Form 3160-5
(June 2019)UNITED STATES
DEPARTMENT OF THE INTERIOR
BUREAU OF LAND MANAGEMENTFORM APPROVED
OMB No. 1004-0137
Expires: October 31, 2021**SUNDRY NOTICES AND REPORTS ON WELLS**
Do not use this form for proposals to drill or to re-enter an
abandoned well. Use Form 3160-3 (APD) for such proposals.

8. Well Name and No. DEEP ELEM 4 FED COM/591H

9. API Well No. 3001547940

EOG respectfully requests an amendment to our approved APD for this well to reflect the following changes:

Revised Wellbore A:

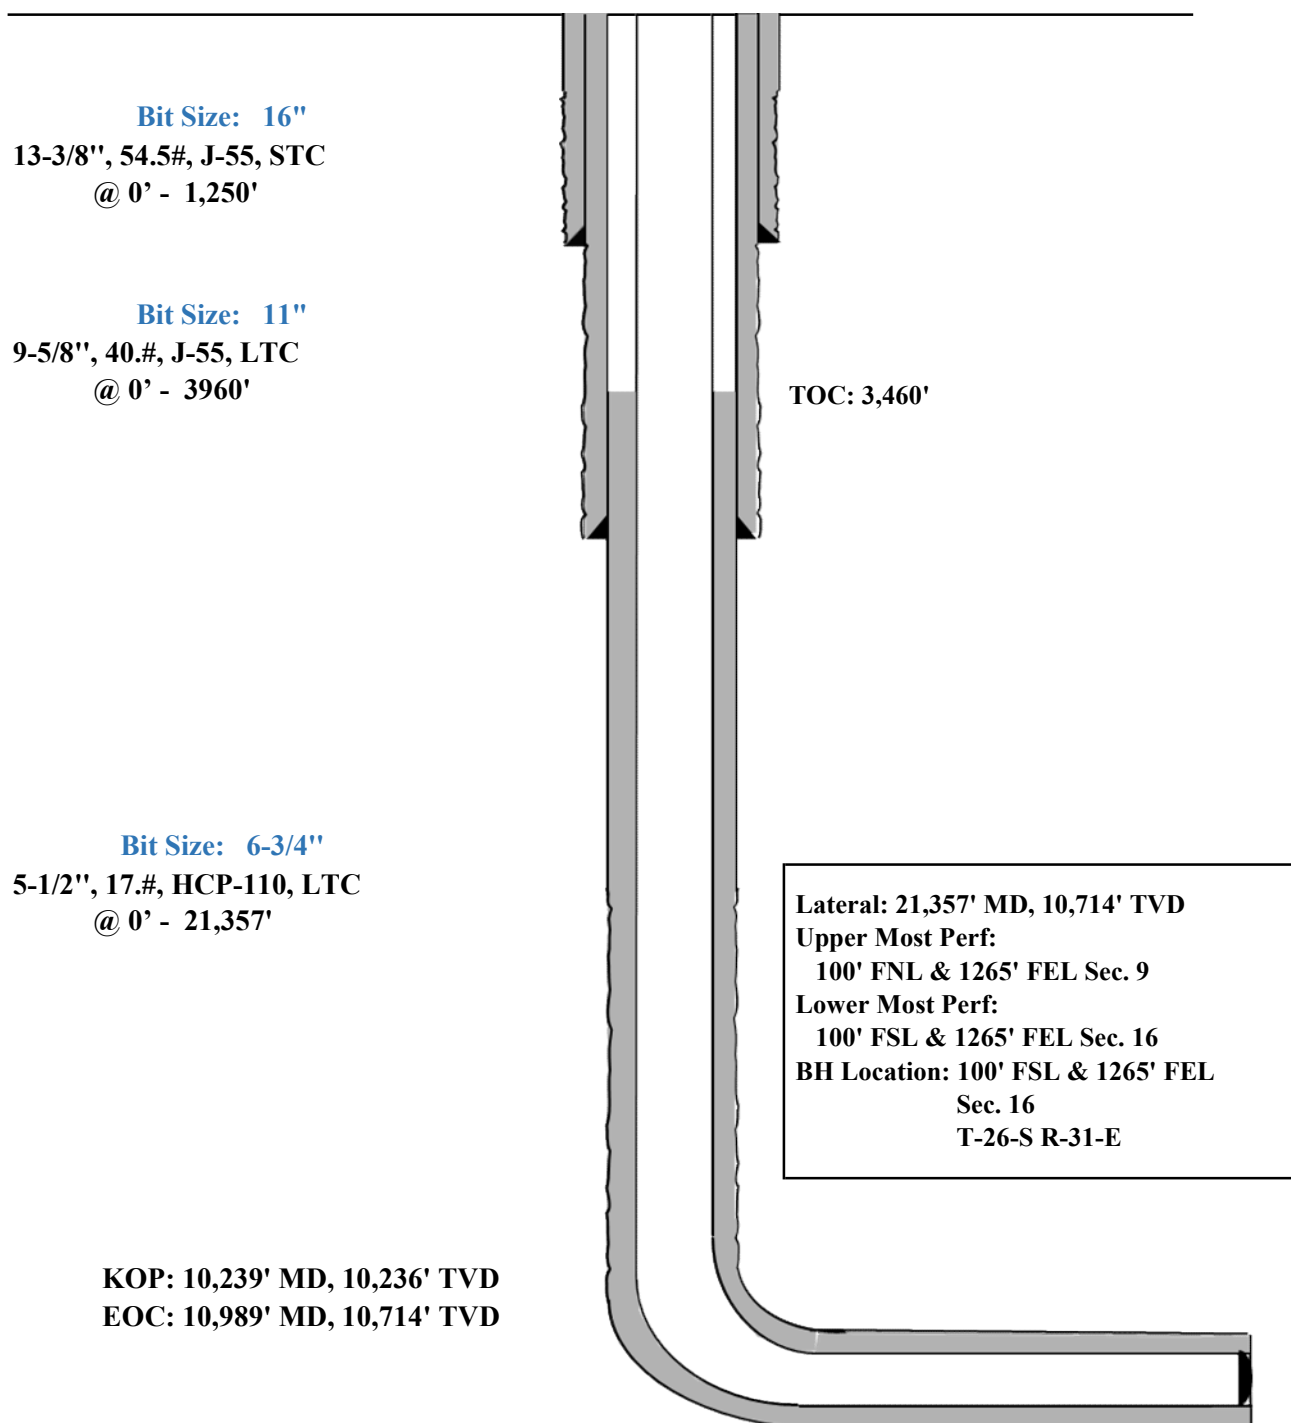
Change BHL from T-26-S, R-31-E, Sec 16, 100' FSL, 797' FEL, Eddy Co., NM,
to T-26-S, R-31-E, Sec 16, 100' FSL, 1265' FEL, Eddy Co., N.M.

Update casing and cement program to current design.
